Burlington Development Review Board

Development Review Board

TO: Development Review Board
FROM: Garret King
DATE: November 21, 2023
RE: ZP-23-412; 14 Myrtle Street

TO: Development Review Board
FROM: Garret King
DATE: November 21st, 2023
RE: ZP-23-331; 71 Temple Street

14 Myrtle St
Burlington VT

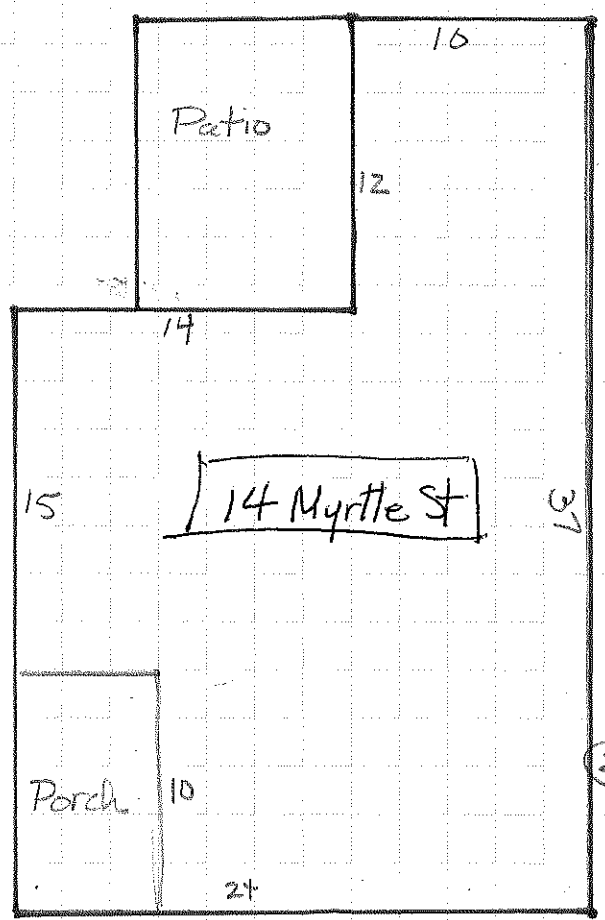
(m) Landscaping, fences, and retaining walls
The proposed plan shows the removal of a rear yard fence that runs along the rear property line.
(Affirmative finding)

I received a notice for the DRB meeting in regards to ZP-23-412, scheduled for Nov 21. Unfortunately, I am out of town for a while and will not be able to attend but I would like to submit a request / comment. Proposed removal of the chain link fence between Ms. Czina's and my property means removal of the only indication of the property boundary line. Given the previous history with this particular neighbor, I would like to make sure that Ms. Czina understands that 2ft behind the chain link fence, leading up to the wooden fence, is the property of 170 Park St, and not the extension of hers. There should be no changes, landscaping or gardening of any kind in this setback area, since me and my team will have to use it for the fence maintenance, as per City orders. Can we add a condition to the chain link fence removal - to replace it with any kind of edging that will indicate the property boundary, which was the purpose of the chain link fence that she decided to remove?

I am trying to avoid any potential conflict with Ms. Czina, and can certainly see this becoming an issue, if not addressed in advance. Can you please help with this?

14 Myrtle Street
Shed Replacement/Rebuild.

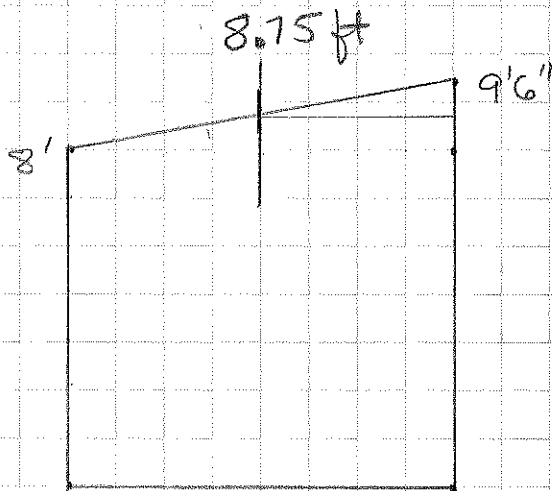
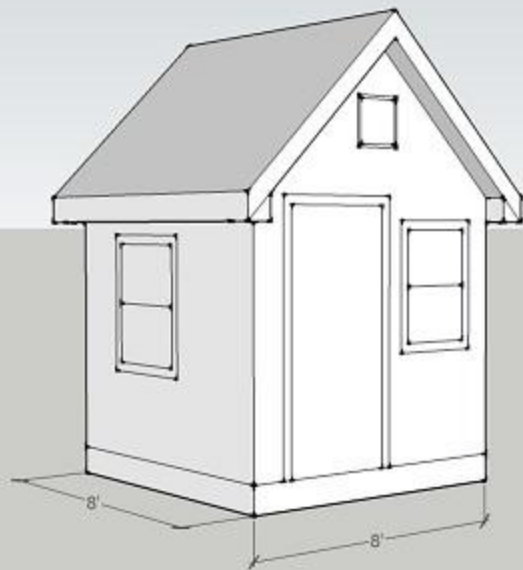
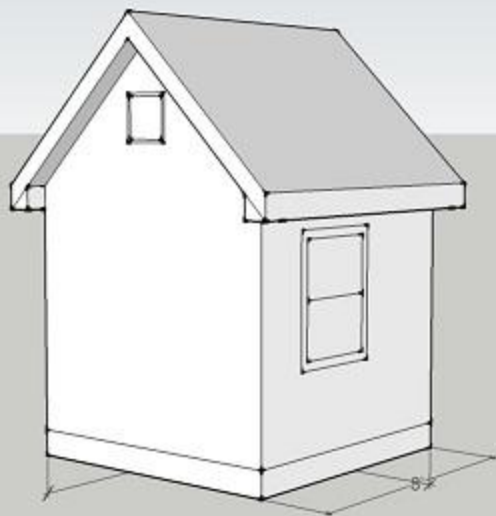
Proposed shed
midline roof height ~~8'6"~~ 10.25 ft.

existing shed
midline roof height ~~8'6"~~ 8.75 ft

SITE PLAN

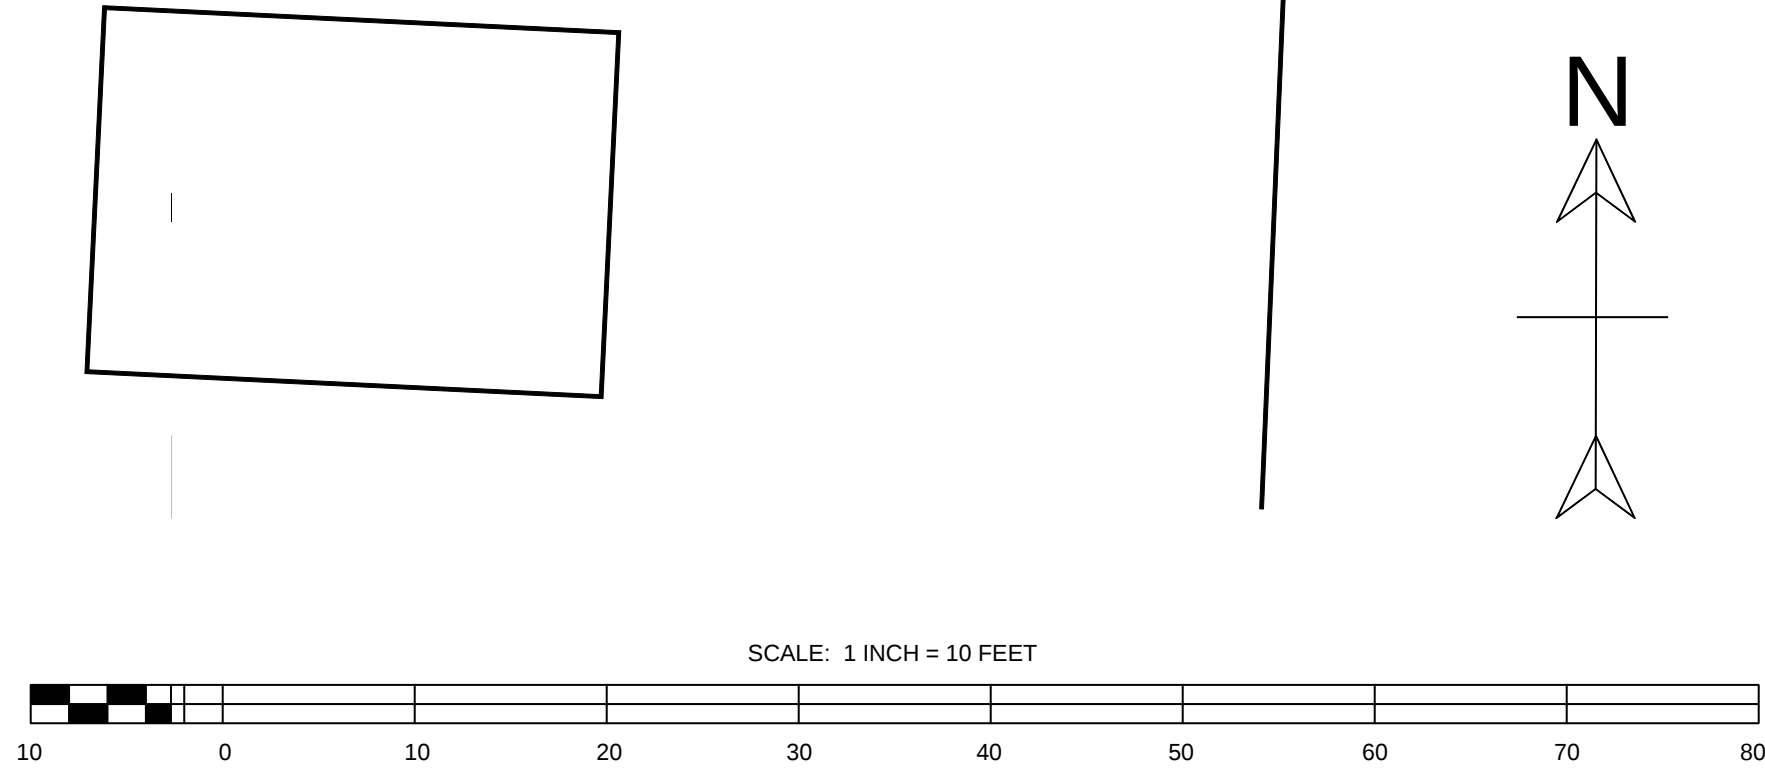
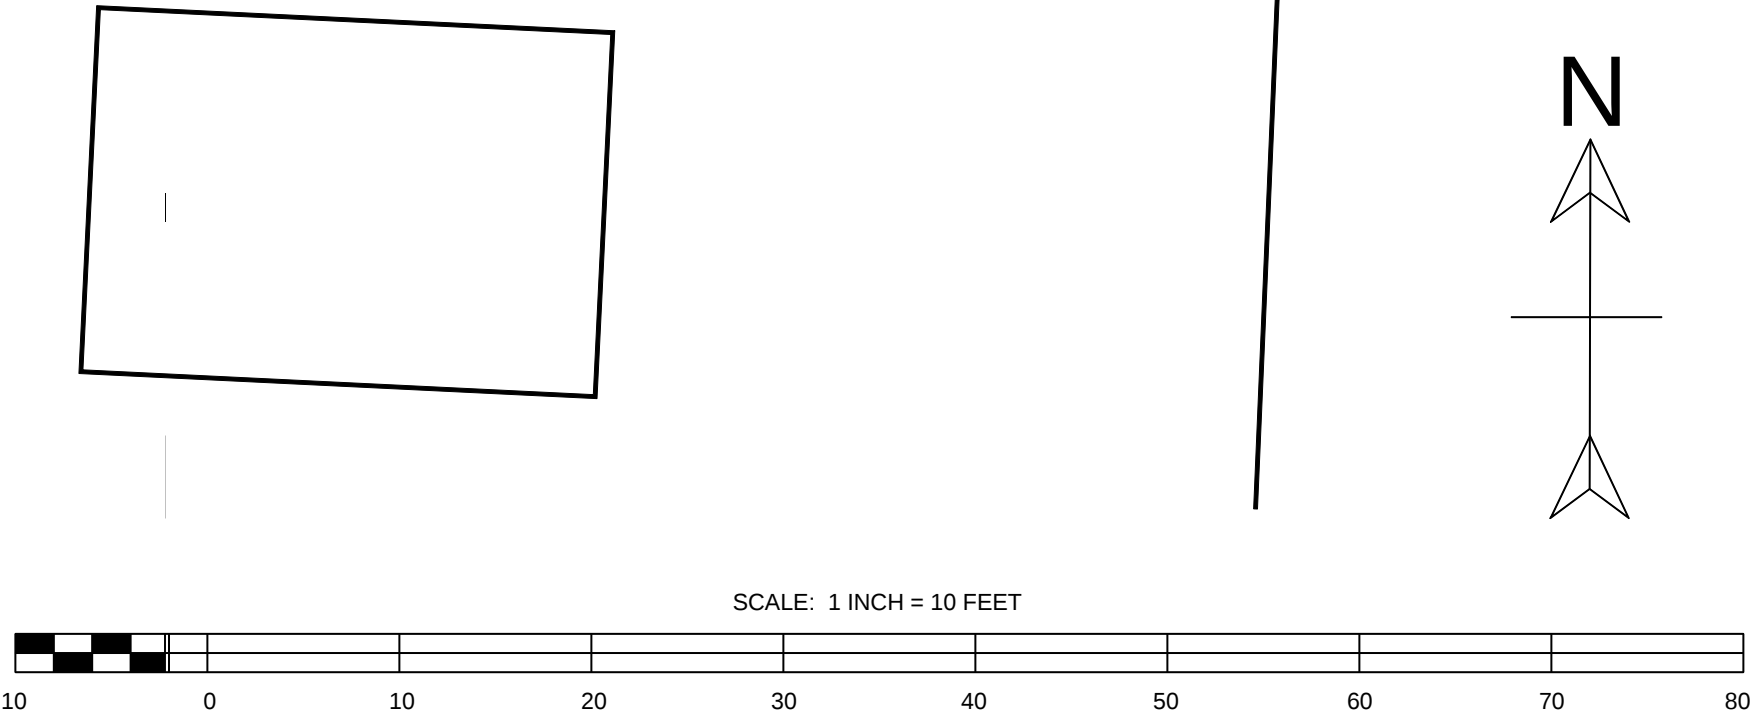
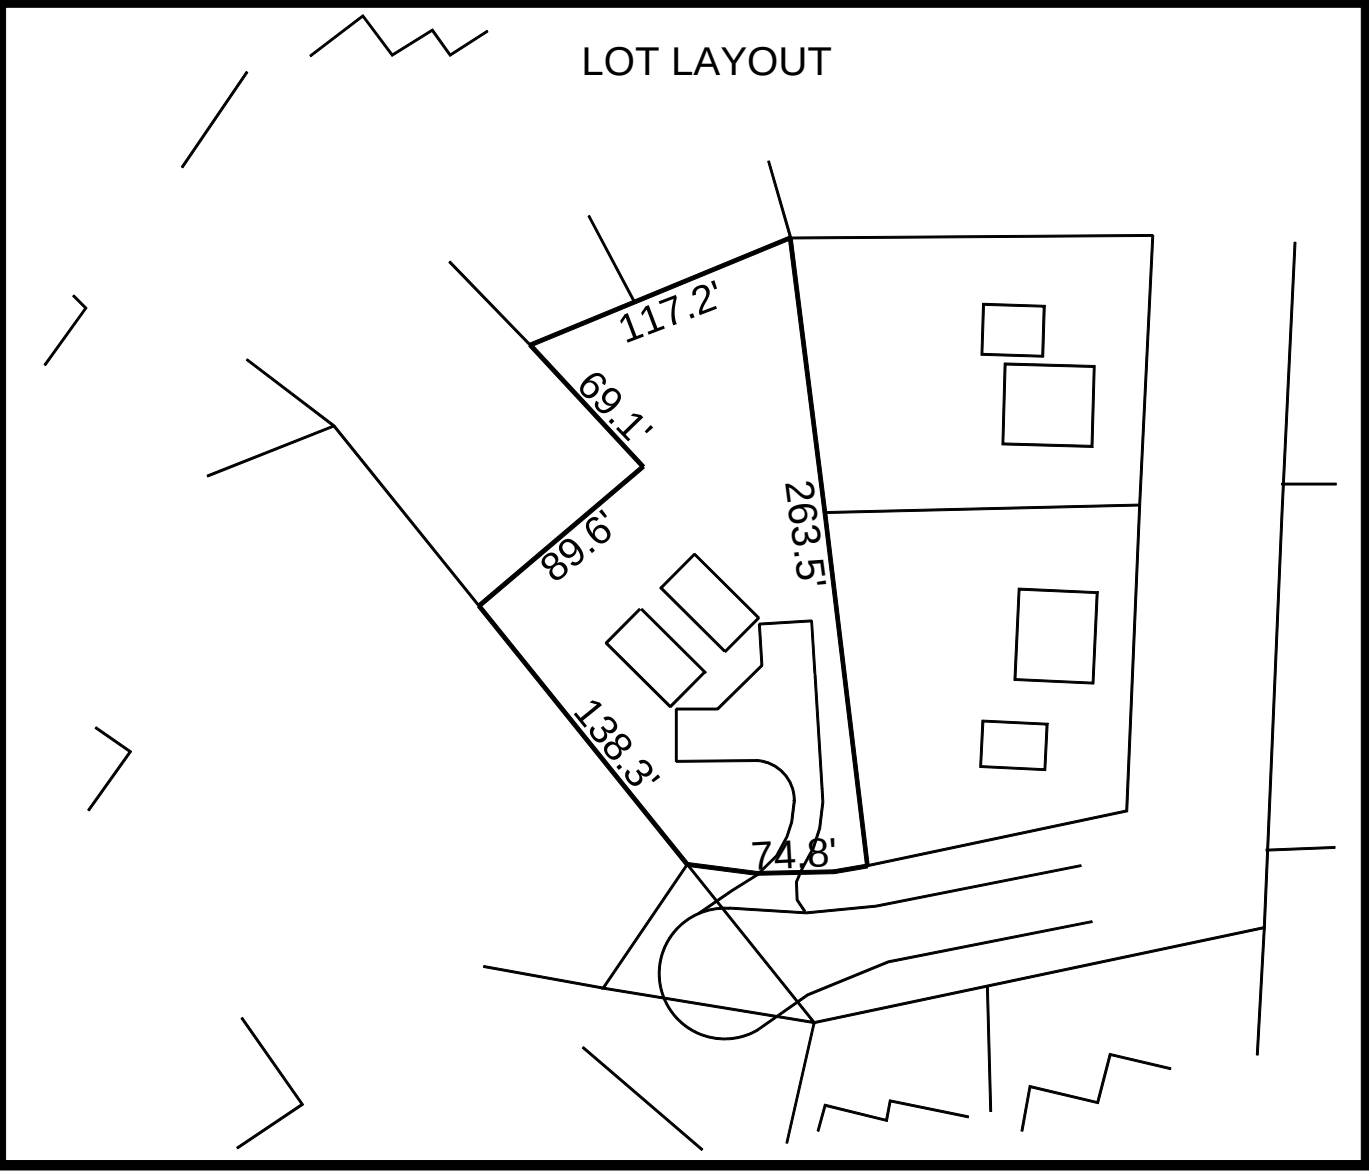
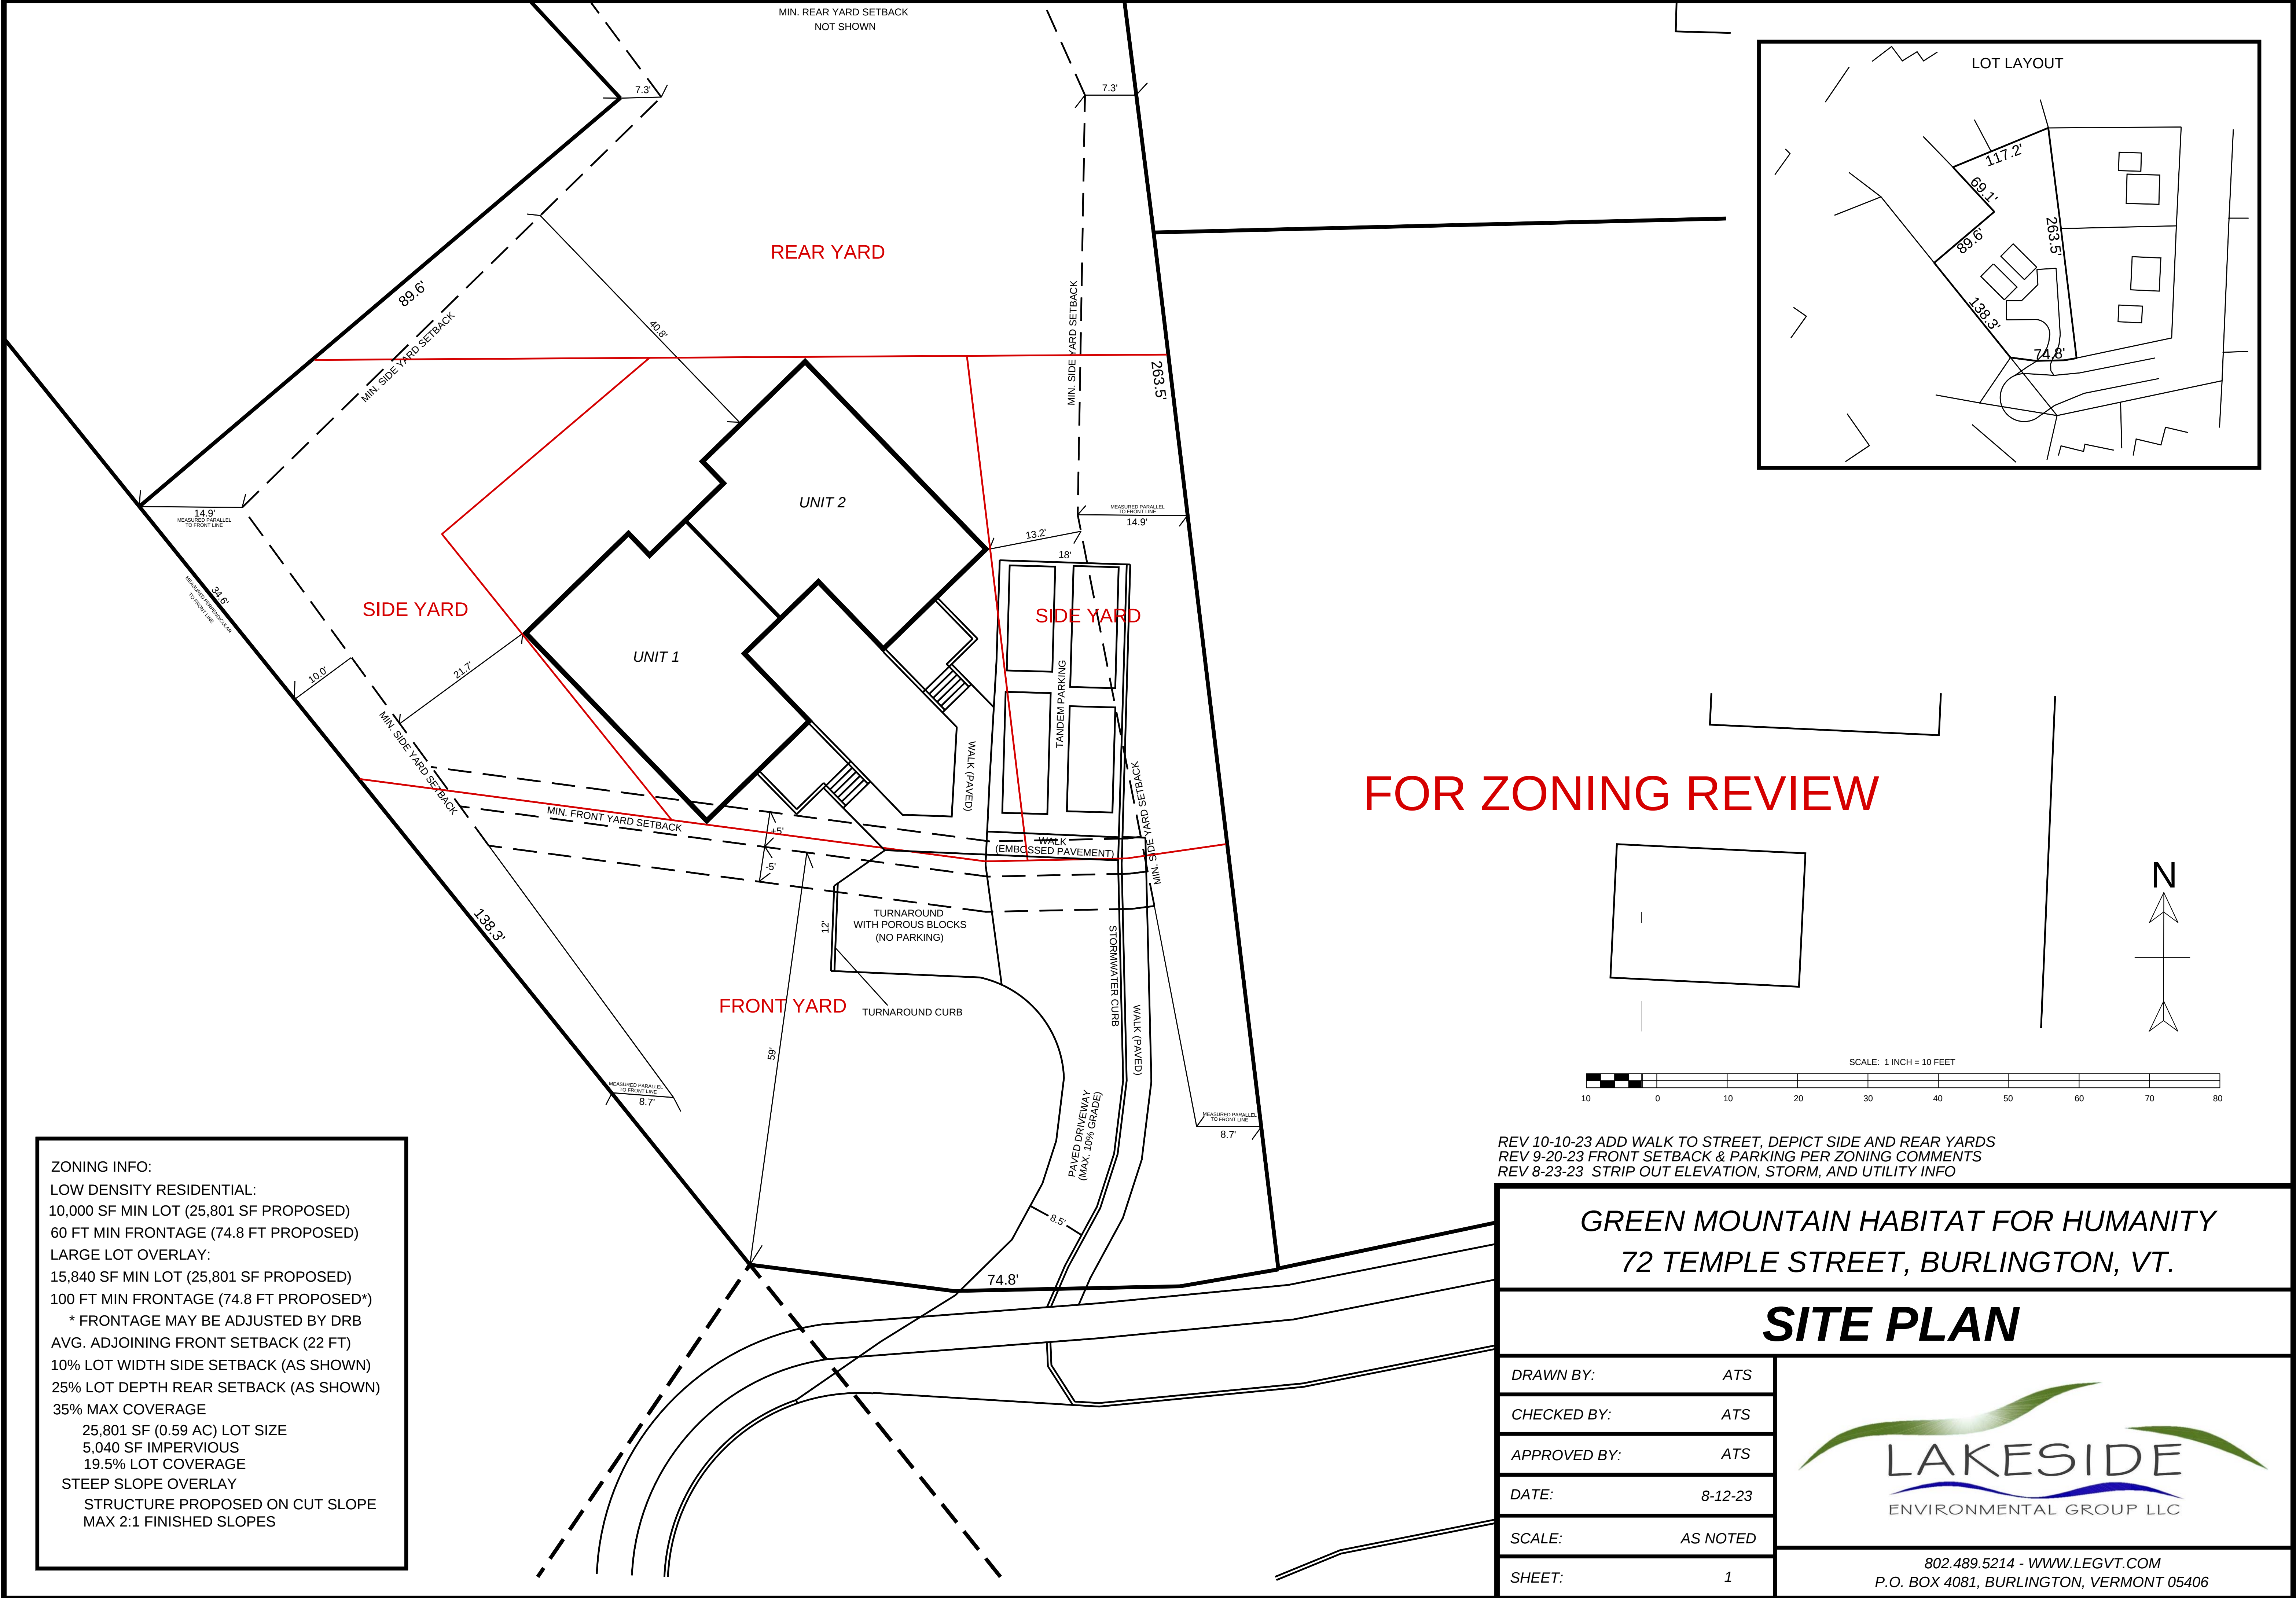
A site plan showing all cuts and fills associated with this project will have to be approved by the City Engineer. **(Affirmative Finding as Conditioned)**

No retaining walls are proposed. A site plan showing that the site will be properly stabilized will have to be approved by the City Engineer. **(Affirmative Finding as Conditioned)**

Final site plans with finished grades must be approved by the City Engineer. **(Affirmative Finding as Conditioned)**

Parking will be provided in tandem arrangement within the driveway. As proposed, the driveway curves across the property as it approaches the house. A proposed turn-around reaches in front of the house to the west. Much of the front yard is driveway or turn-around. This criterion calls for

parking to be placed to the side or rear of the structure. Sec. 8.1.12 (b), *Front Yard Parking and Residential Driveways*, expressly requires it in residential districts. Also the parking area will be required to have physical barriers to prevent vehicles from encroaching into adjacent green spaces. The Design Advisory Board considered this arrangement during their review of the application and discussed alternatives. A flat site could easily accommodate revision; however, the sloped topography of the site is the driving factor in the proposed arrangement. As with other similar proposals, the turn-around is to be made of material different from the driveway. The DAB supported the site layout as proposed. **(Affirmative Finding)**

REV 9-20-23 FRONT SETBACK & PARKING PER ZONING COMMENTS

REV 10-10-23 ADD WALK TO STREET, DEPICT SIDE AND REAR YARDS
REV 9-20-23 FRONT SETBACK & PARKING PER ZONING COMMENTS
REV 8-23-23 STRIP OUT ELEVATION, STORM, AND UTILITY INFO
